MATERIALS LICENSE

Amendment No. 09

In accordance with letter dated
September 13, 19963. License Number 34-18728-01 is amended in
its entirety to read as follows:

RE: License #34-18728-01

THIRD FLOOR

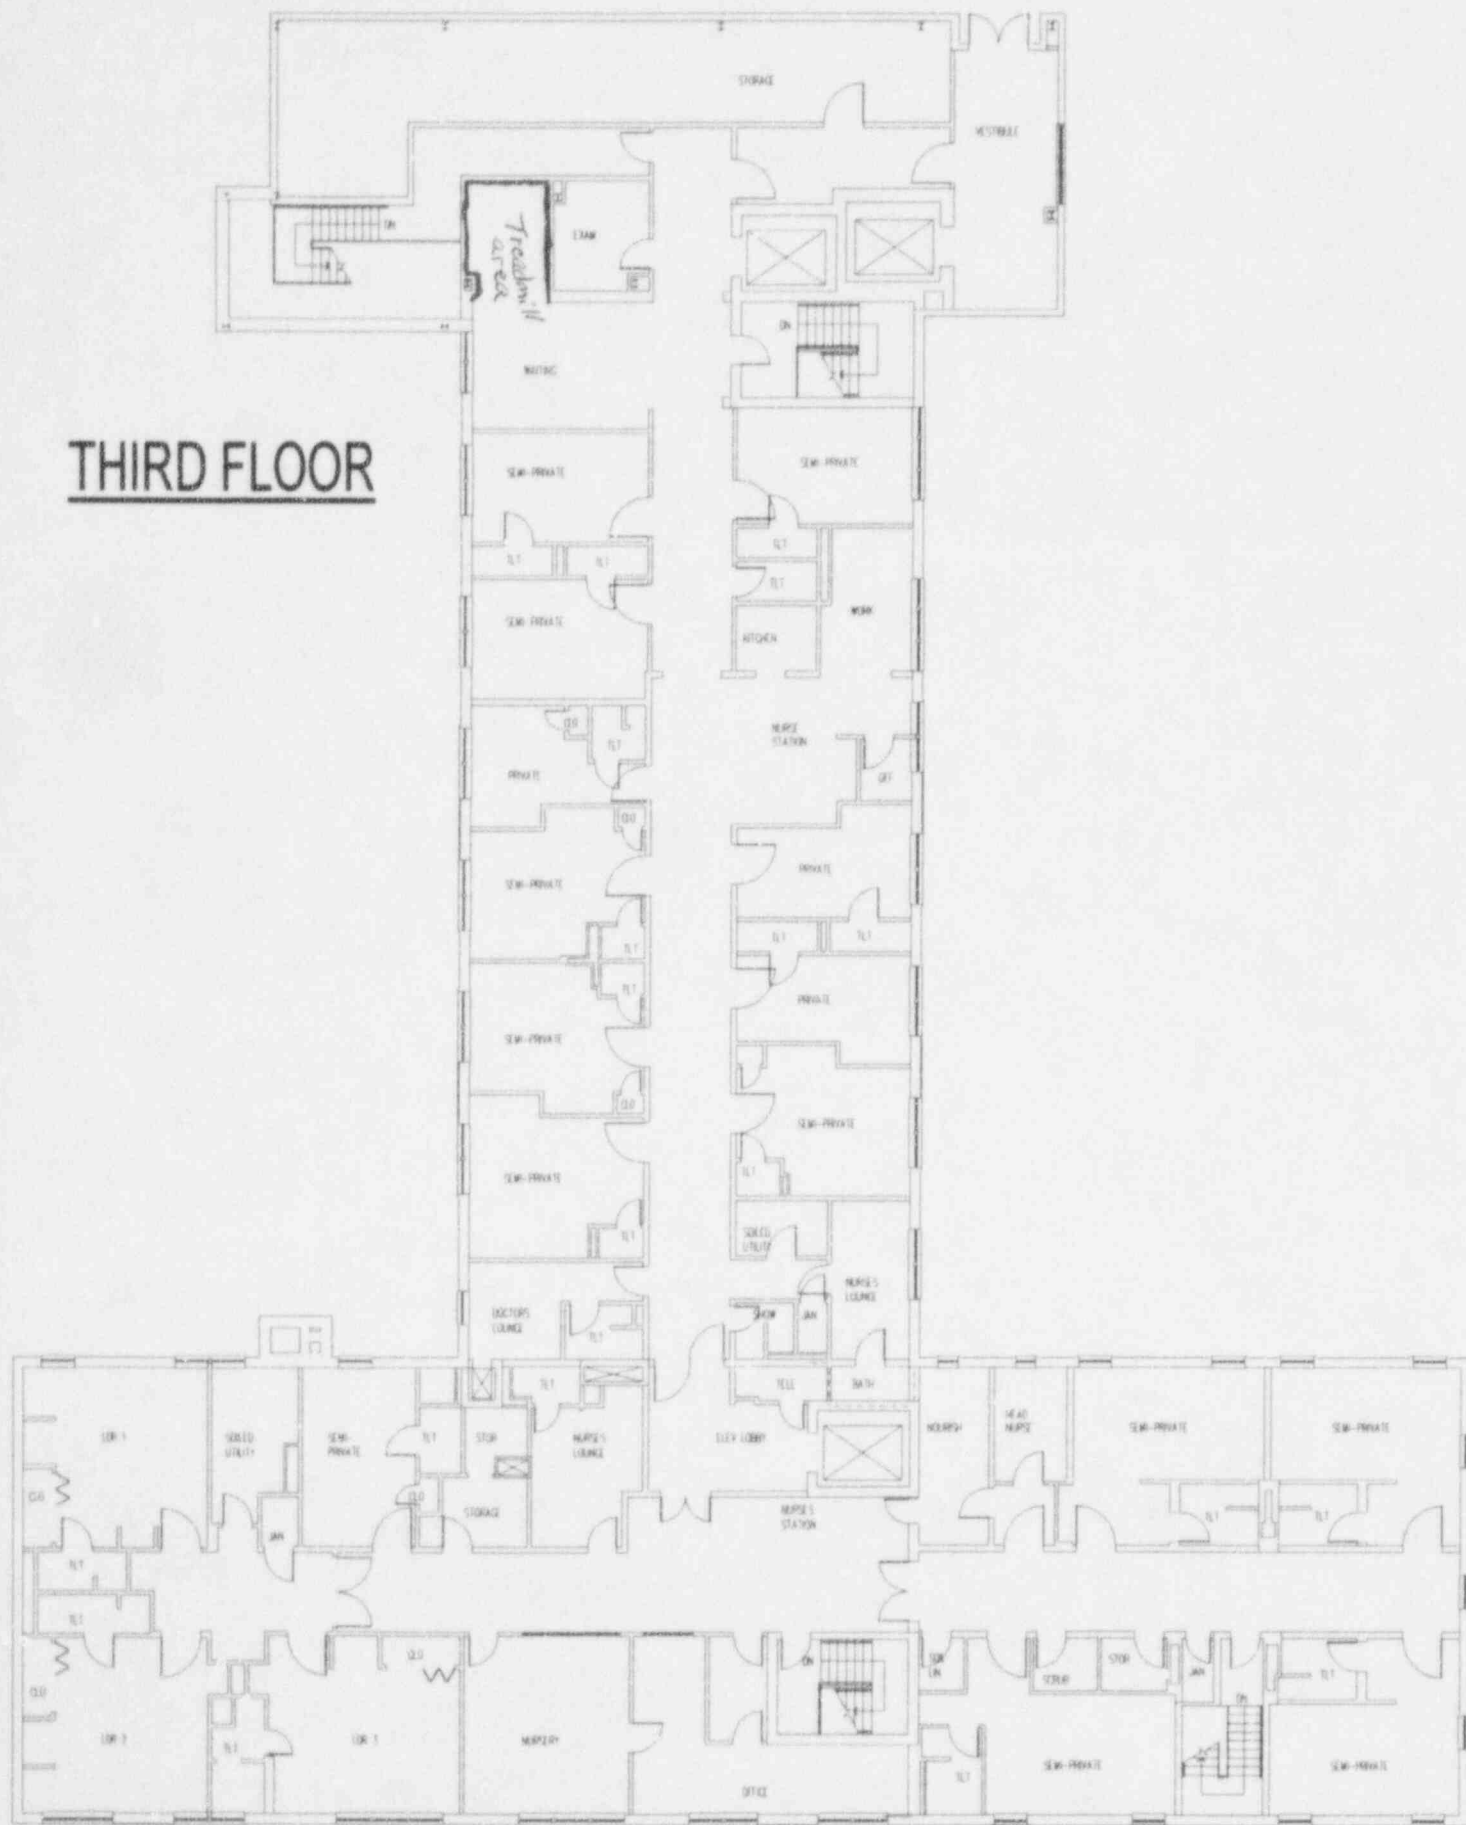
Also included is a map of the area that will be utilized until we are able to return to our regular location. This area will be used primarily for cardiac treadmill and pharmacologic procedures involving the use of Technetium 99m and Thallium 201.

The entrance to this area will be posted with a sign stating: "Caution-Radioactive Material" during the use of the radiopharmaceutical. At the end of the day, the area will be surveyed with and Action/Trigger Level of 0.2mR/hr. If the survey is below the Action Level, the sign will be removed from the entrance. A wipe test of the area will be performed on a weekly basis during this transition period.

A close-out survey and wipe test will be performed of this area before equipment is returned to the regular location on the second floor.
